SERVICE BULLETIN

ENGINE - LP TURBINE ASSEMBLY - REPLACEMENT OF LP TURBINE BLADES STAGE 3 - CATEGORY CODE 6 - MOD.ENG-72-0134

V2500-ENG-72-0134

Shingling of LP turbine stage 3 rotor blades – preparation of build up welding
Fig.1

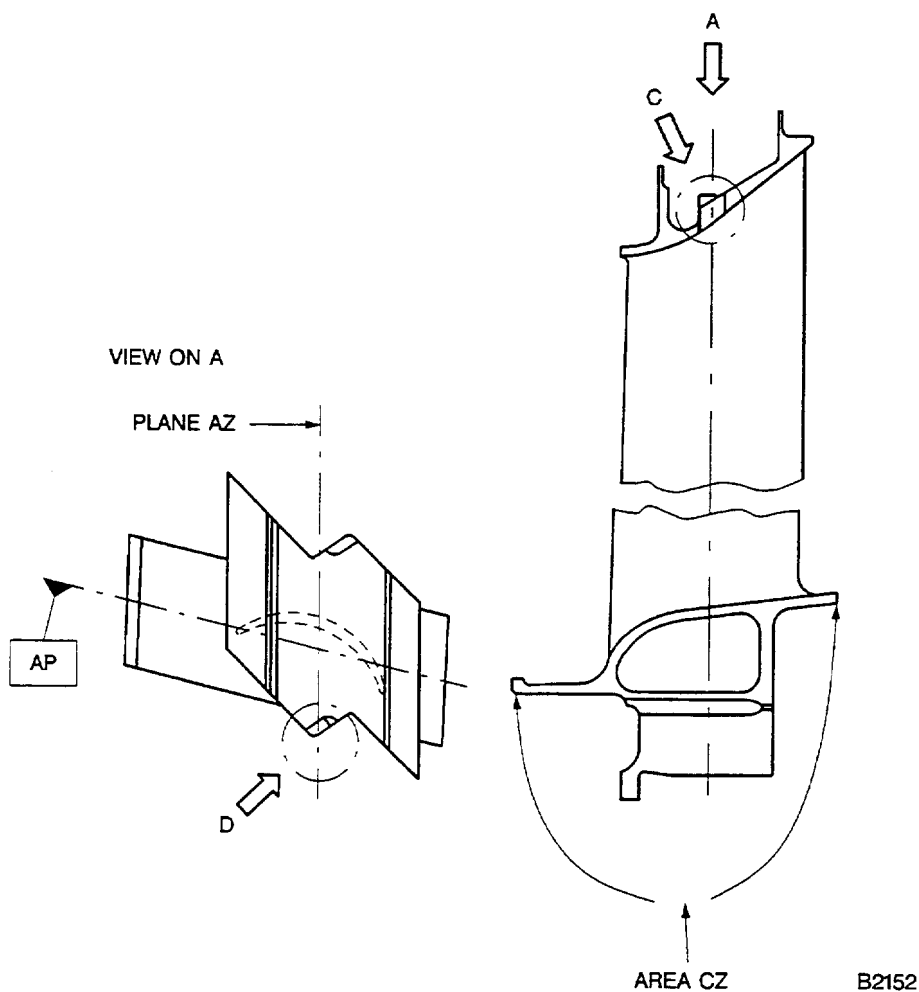
Turbine blade outer shroud overlap (shingling) may occur when handling or reassembling Stage 3 LP turbine rotor assemblies with used turbine blades.

To ensure the correct assembly of Stage 3 LP turbine rotor blades by introducing a blade outer shroud stop on existing blades.

To increase shroud thickness locally.

- (1) Do the rework of stage 3 LP turbine blade P/N 3A0883.

| Procedure | Supplementary Information | | | | |
|--|---|-----------------|-----------------|--------|--------|
| (a) Identify stage 3 LP turbine blade part number 3A0883. Inspect LP turbine blade per Engine Manual | Refer to Reference (3), TASK 72-50-32-200-000, Table Inspection | | | | |
| (b) Repair the blade if applicable | | | | | |
| (c) Prepare the blade for build-up welding | Locally remove aluminide coating from shroud surface (refer to figure 1). Install the blade in to IAE 3M14382 welding fixture (1 off). | | | | |
| (d) Build up weld the shingling stop | Refer to Reference (4), TASK 70-31-08-310-501. Use CoMat 03-283 welding filler wire to the dimensions given in figure 2. Electrical contact in area CZ is permitted. No burning, no pitting, no selective attack are permitted. | | | | |
| (e) Check dimensions | Refer to requirements given in figure 2. | | | | |
| (f) Do a hardness check on the weld location | Minimum hardness 40 HRC. | | | | |
| (g) Do a crack test on the weld location | Refer to Reference (4), TASK 70-23-05-230-501. Discontinuities up to 0.016in. (0,4 mm) are permitted. | | | | |
| (h) Reidentify with new part number. Use roller stamp method or vibropeen method | <table><tr><td>Old Part Number</td><td>New Part Number</td></tr><tr><td>3A0883</td><td>3A2053</td></tr></table> Refer to Reference (4), TASK 70-09-00-400-501 (refer to figure 3). | Old Part Number | New Part Number | 3A0883 | 3A2053 |
| Old Part Number | New Part Number | | | | |
| 3A0883 | 3A2053 | | | | |

Reidentification of LP turbine stage 3 rotor blades
Fig.3

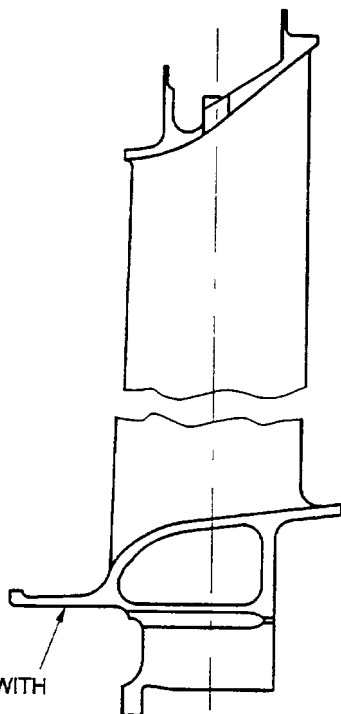
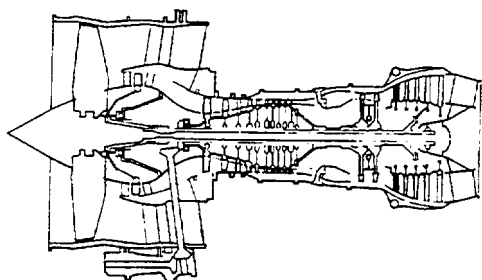
REIDENTITY WITH
PN3A2053

(1D) Old part can be removed and reidentified to the new part number
